P802.3bt D3.0 – PD input power v120

145.3.2 PD PI input power

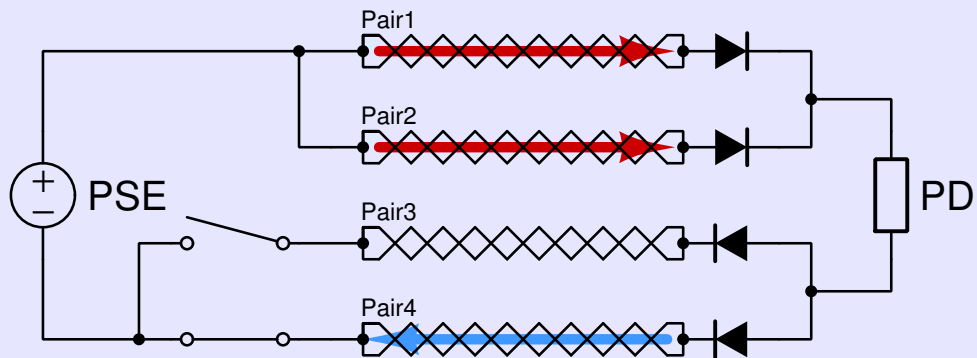
2-pair In this mode 2 pairs are energized: one for the positive, one for the negative. Power can be provided either via Pair 1 and Pair 3, or via Pair 2 and Pair 4. Any polarity configuration must be supported by the PD.

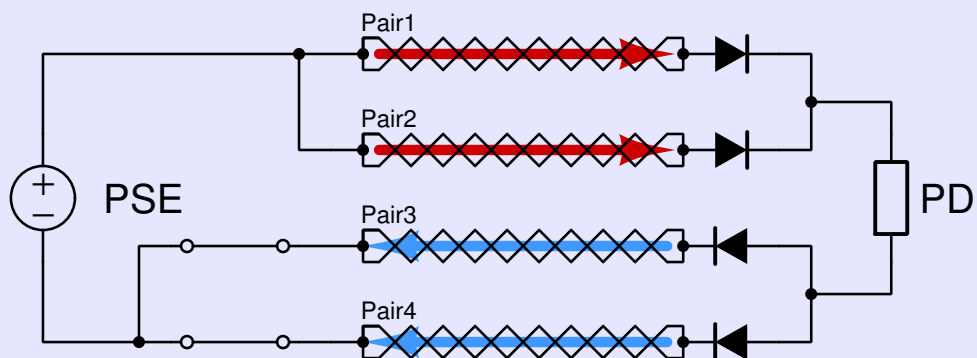
3-pair This is what typically will happen when a 4-pair capable PSE delivers power in “2-pair mode”. Most PSEs only have switches on the negative side, which means that power is always provided via two positive pairs, regardless of being in “2-pair mode” or “4-pair mode”.
